EMERGENCY CORE CCOLING SYSTEMS

ATTACHMENT B PROPOSED AMENDMENTS TO THE LICENSE/TECHNICAL SPECIFICATIONS

CECo NED Nuclear Design Information Transmittal (NDIT) No. E1C-93-011-2, dated 6/3/94, summary report of the calculations that determine the ECCS system "Keep Filled" Alarm Ideal Setpoint and Technical Specification Allowable Values.

LASALLE STATION - UNIT 1 & 2 ECCS SYSTEM "KEEP FILLED" ALARM IDEAL SETPOINT AND TECH SPEC ALLOWABLE VALUE

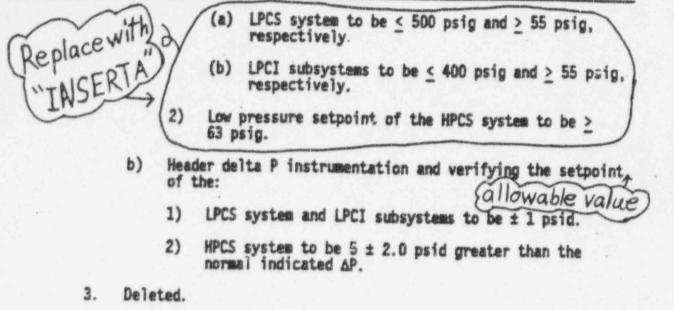
- Discharge line 'keep filled" pressure alarm instrumentation (8 and verifying the: fallowablevalue
 - High pressure setpoint and the low pressure setpoint 1) of the:

INSERT A

(a)	LPCS system to be ≤ 500 psig and ≥ 45.5 psig, respectively.
(b)	LPCI subsystem "A" to be ≤ 400 psig and ≥ 41.0 psig, respectively.
(c)	LPCI subsystem "B" to be ≤ 400 psig and ≥ 38.5 psig, respectively.
(d)	LPCI subsystem "C" to be ≤ 400 psig and ≥ 45.0 psig, respectively.
Low proceuro cot	point allowable value of the HPCS system

Low pressure setpoint allowable value of the HPCS system to be ≥ 42.5 psig.
